SAFETY EVALUATION BY THE OFFICE OF NUCLEAR REACTOR REGULATION
RELAXATION REQUEST FROM ORDER EA-03-009 REGARDING THE
BARE METAL VISUAL EXAMINATION OF THE REACTOR PRESSURE VESSEL HEAD
FACILITY OPERATING LICENSE NO. NPF-6
ENTERGY OPERATIONS, INC.
ARKANSAS NUCLEAR ONE, UNIT 2
DOCKET NO. 50-368

Figure 3

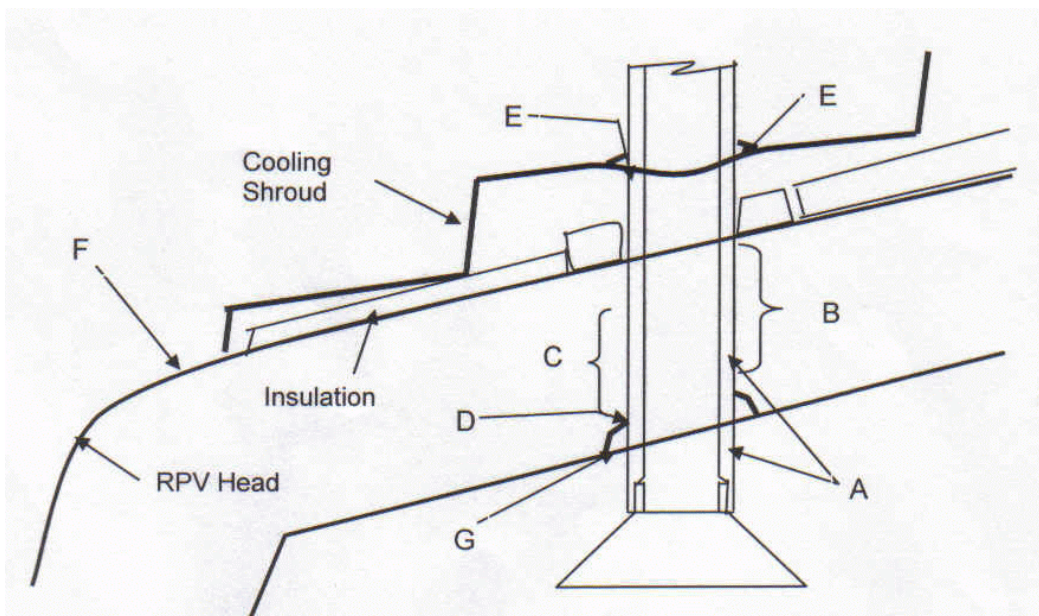
- **A = Volumetric Examination** of CEDM/ICI penetration tubes utilizing MRP-demonstrated UT techniques. This ensures that the critical length of the nozzle is free of defects and potential leakage paths.

- **B = Low Frequency Eddy Current Examination** of the portion of the CEDM and vent line penetrations that are above the J-groove weld. This examination will interrogate the area between the penetration tube and the reactor head, looking for degradation of the carbon steel head material.

- **C = Penetration Annulus Leakage Assessment** using Westinghouse-demonstrated zero degree UT technique. This ensures that the leak path from a leaking nozzle or weld will be detected and qualitatively determined to have a loss of interference fit through the annulus, which can also be detected by LF ETC. This examination can detect leakage through the J-groove weld or through the buttering, if it were to occur.

- **D = Triple-Point Examination** utilizing Entergy/Westinghouse-developed and EPRI/MRP-demonstrated UT technique. This process provides the unique capability to further investigate 0.060" into the J-groove weld and determine the integrity of the penetration weld and to support the conclusion that boric acid deposits will not be present on the RPV head.

- **E = Supplemental Visual Inspection** performed from above the cooling shroud plate, which has the capability of detecting boric acid that has either descended onto the head from Figure 1 above, or has migrated upward from the head and may be visible at the top of the reactor head insulation.

- **F = Bare Metal Visual Inspection** of the accessible portions of the RPV head, including the flange area, part of the lower dome, and around the annulus of the ICI nozzles. This examination is performed to detect corrosion that may have occurred in the accessible areas, to detect leakage around the ICI nozzles, and to look for evidence of boric acid residue that may have run down the head from a leaking penetration.

Figure 4

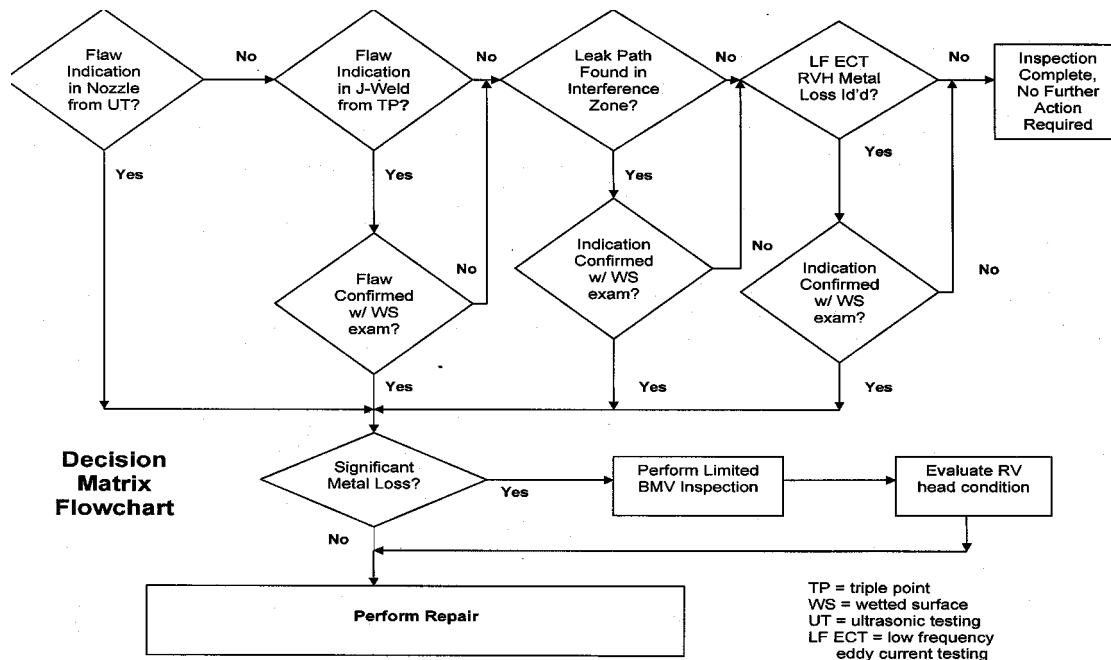
The staff reviewed the decision matrix (Figure 4) to determine if the application of the techniques proposed took into consideration the strengths and weaknesses of the alternatives proposed. The matrix requires that a LF ECT examination be performed after the evaluation of the leak path UT examination. This is an appropriate application of the technique, considering that published data indicates the leak path UT examination is not effective where no interference fit exists between the CEDM nozzle and vessel head penetration. Therefore, a gap must exist for the LF ECT to be an effective technique which, based on the discussion above, must exceed 0.125 inch.

The staff finds that the decision matrix provides a technically sound flowpath to determine if significant wastage exists.
